Dean Moor Solar Farm

Environmental Statement: Appendix 7.8 – Arboricultural Impact Assessment

Deadline: 2

Revision: ~~21~~

Stantec

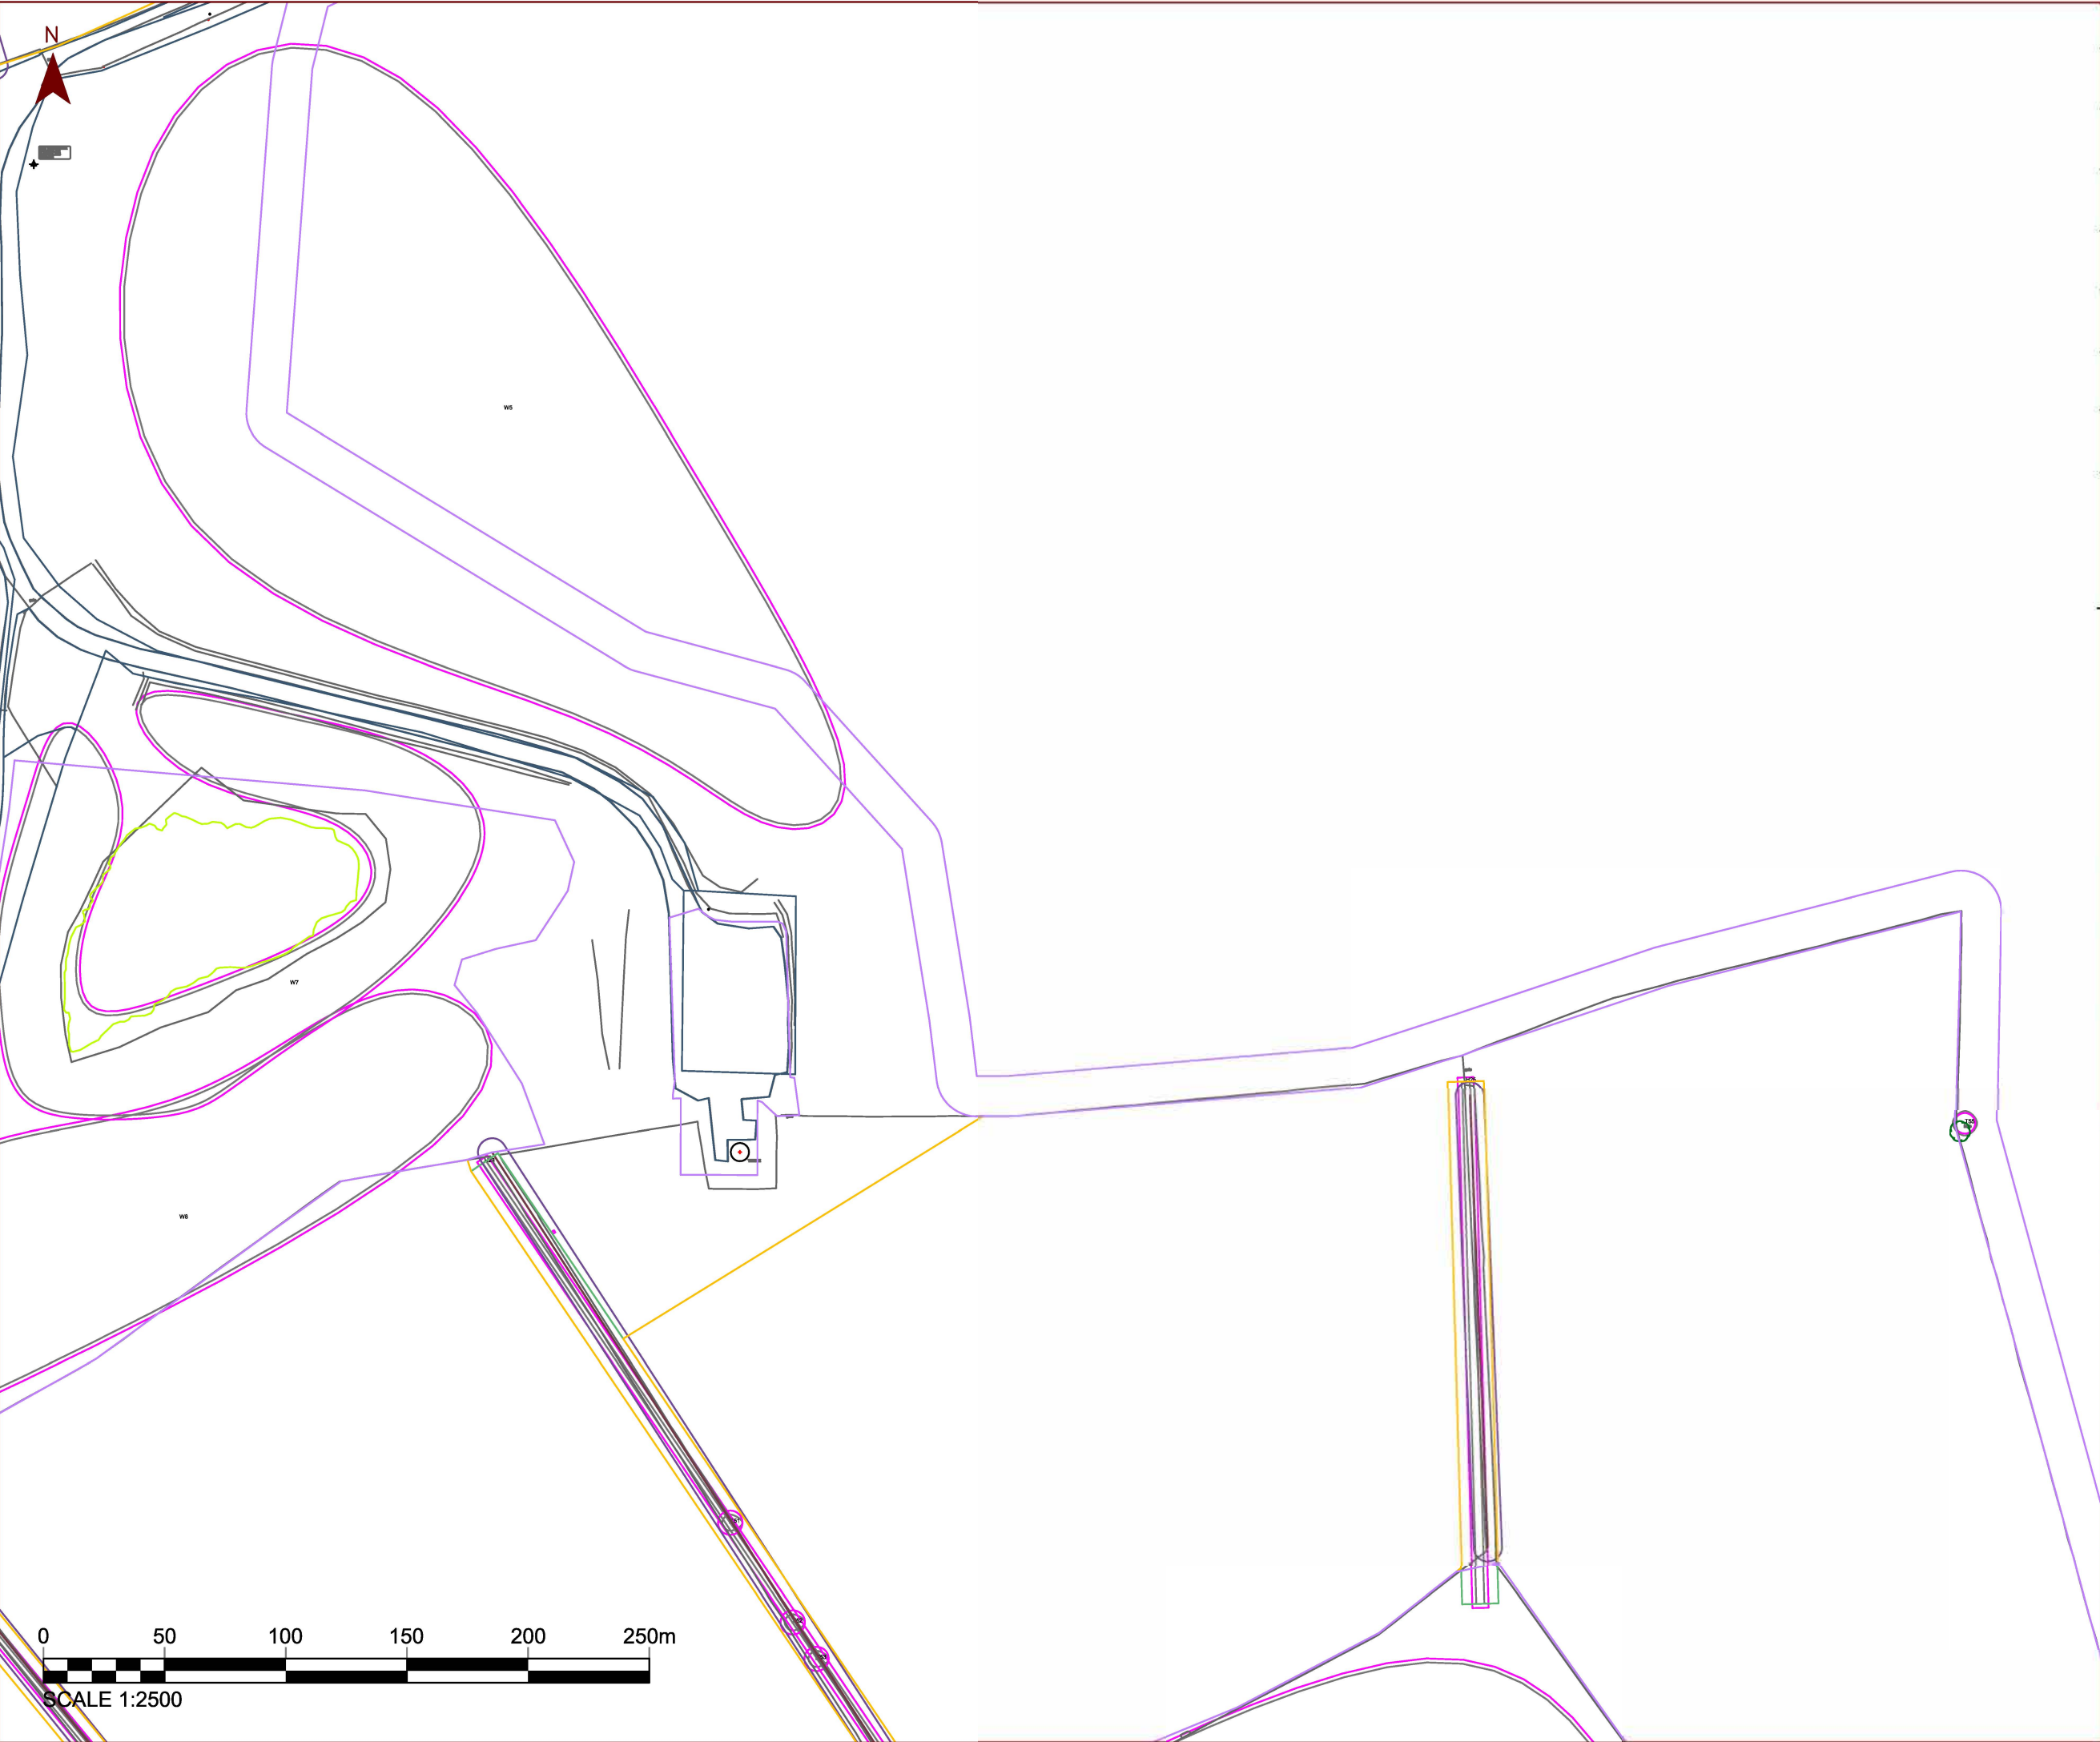
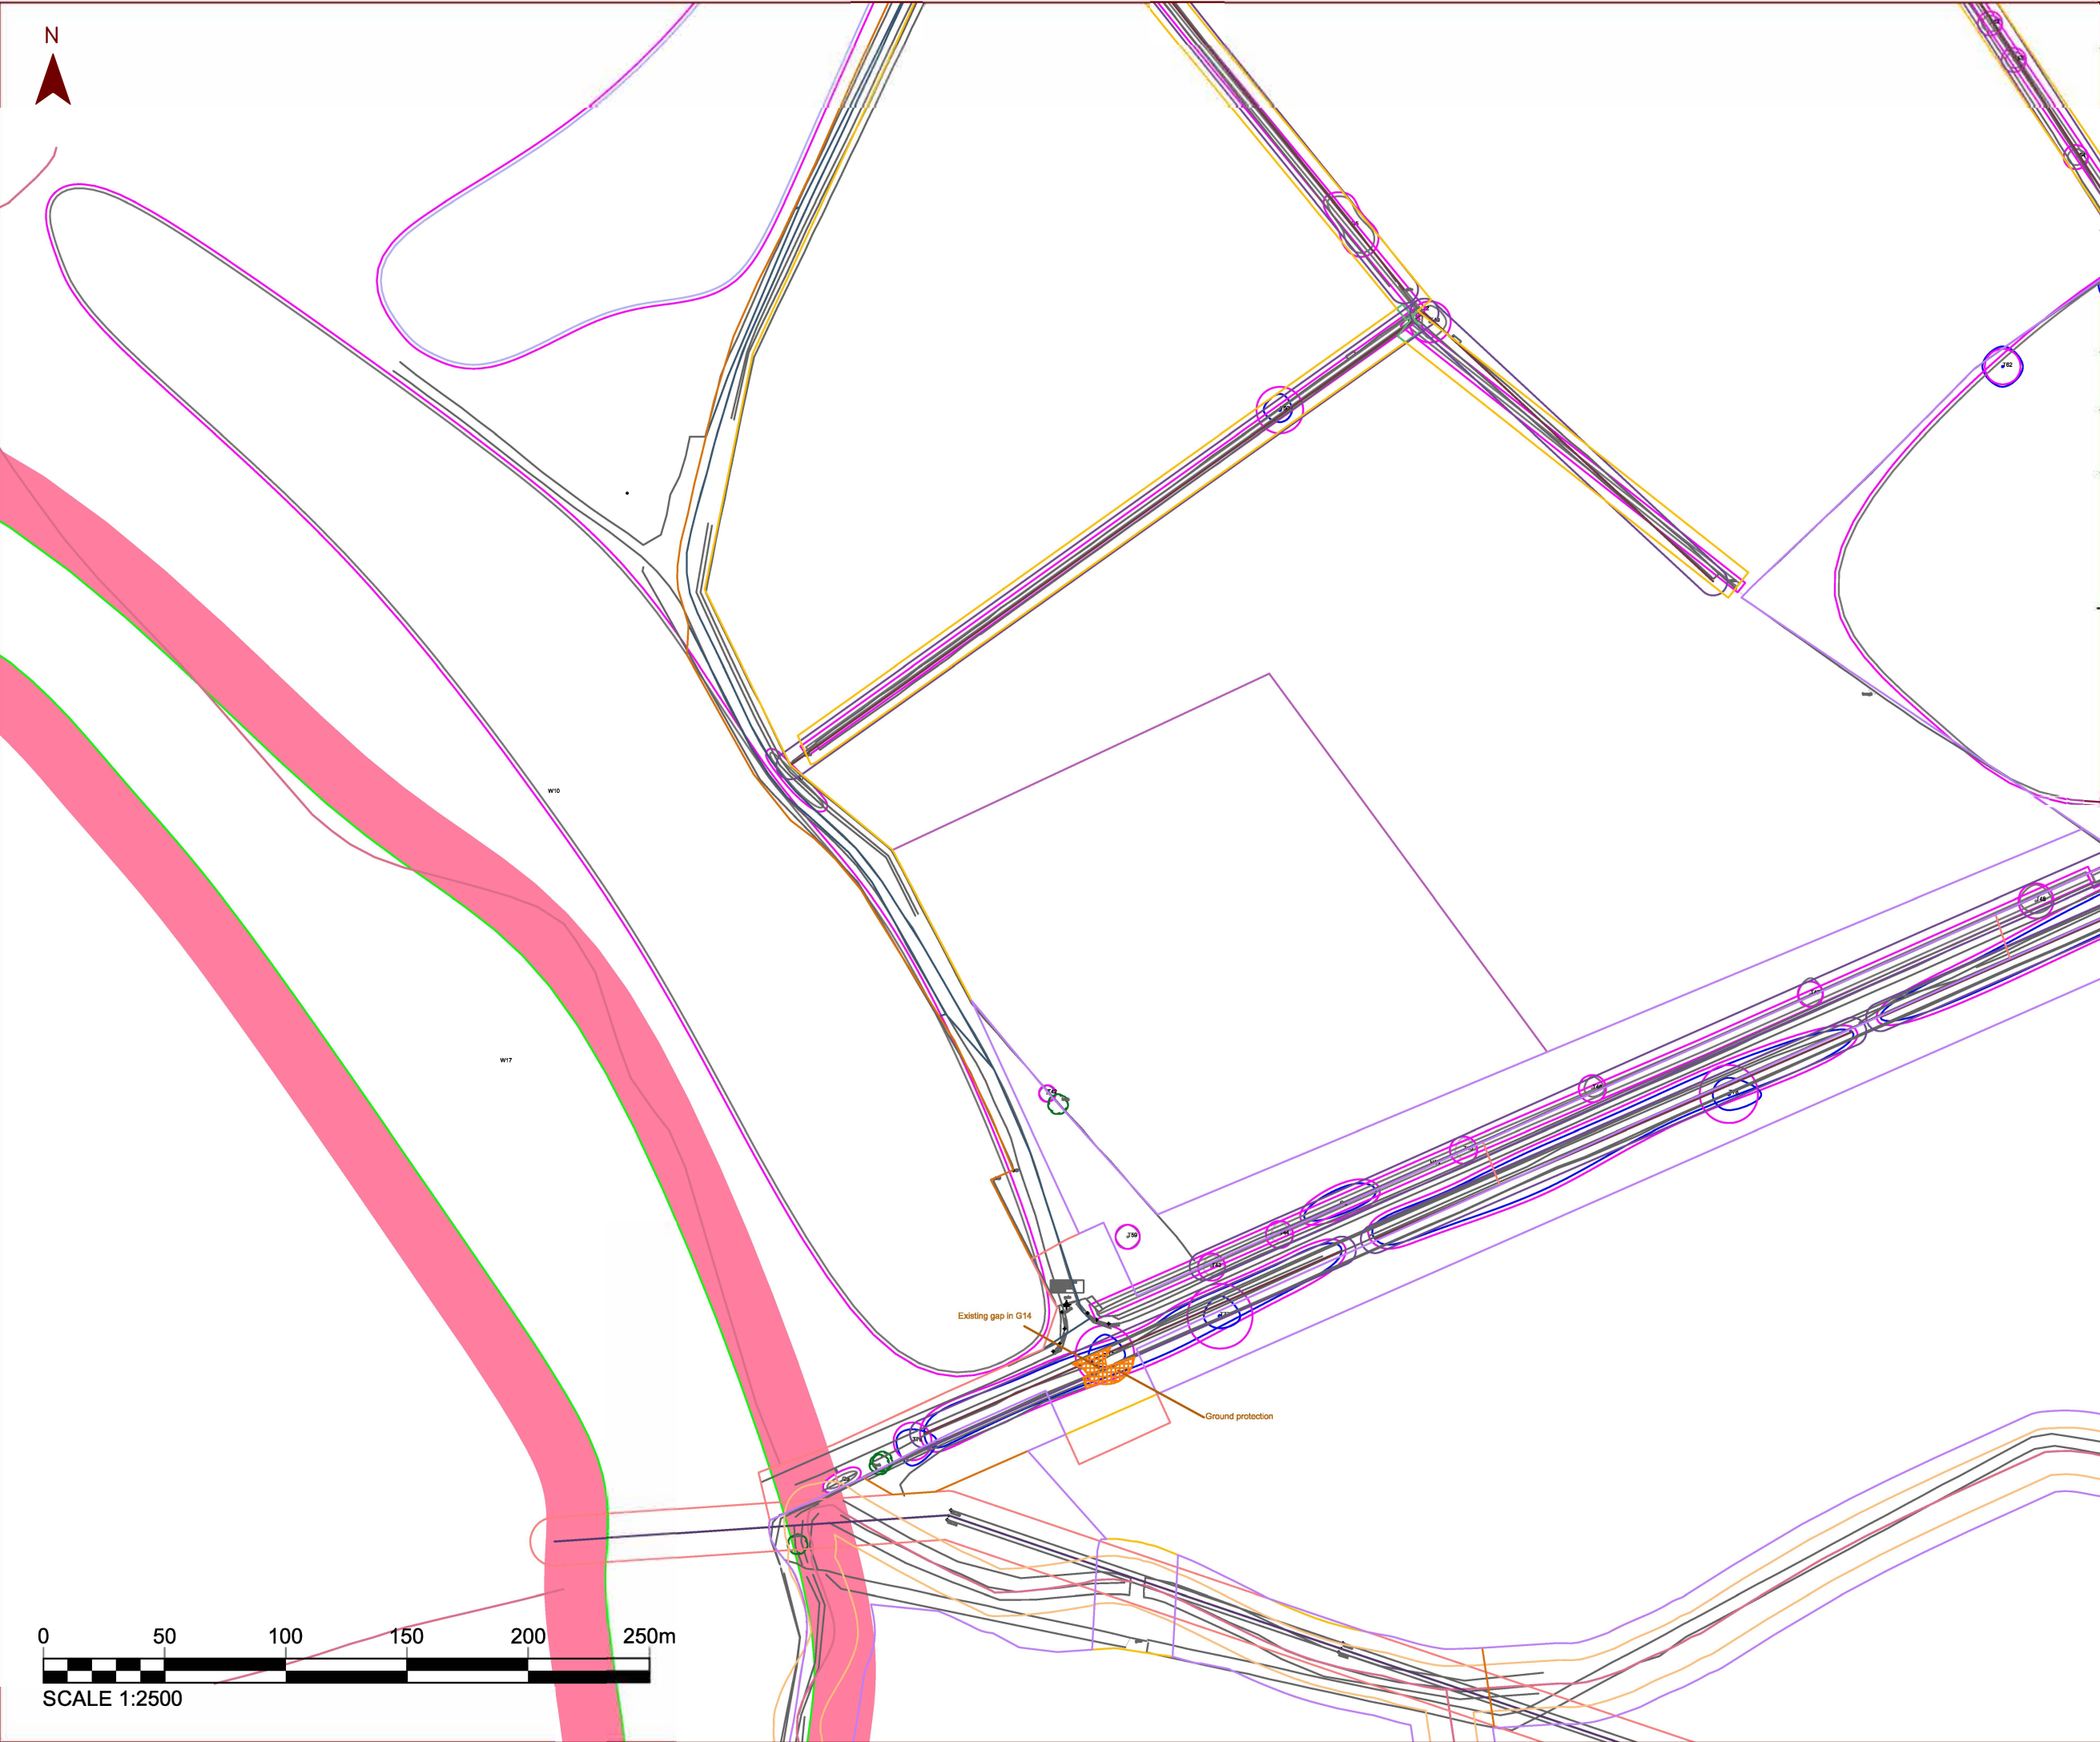
Revision	Reason
Change of the plan title in the TCP from 'Location Plan' to 'Tree Constraints Plan'	To make it clear that the plan is displaying the TCP. As the Location Plan is a different figure within the ES.
A renumbering of the sheets included in the TCP. Changing the order from 0-22 to 1-23.	To enable the first sheet within the TCP is numbered 1 rather than 0.
Change of the plan title in the TPP from 'Location Plan' to 'Tree Protection Plan'	To make it clear that the plan is displaying the TPP. As the Location Plan is a different figure within the ES.
A renumbering of the sheets included in the TPP. Changing the order from 0-22 to 1-23.	To enable the first sheet within the TPP is numbered 1 rather than 0.
